Product Type: ZT331

Ref. No. 008

New Suspension Seat

Models Affected:
942300

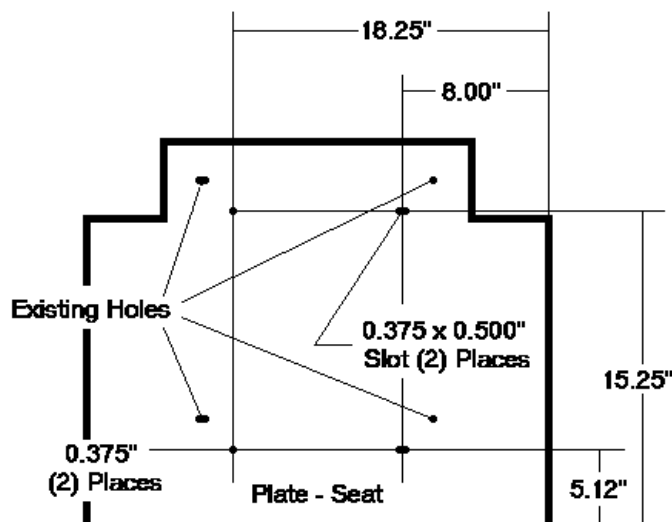
We have replaced the seat on the ZT331 with a New Suspension Seat **970190**.

When ordering a 1985025 seat you will receive a **970190** Seat Kit. Please see the drawing in this bulletin as you will have to drill new mounting holes.
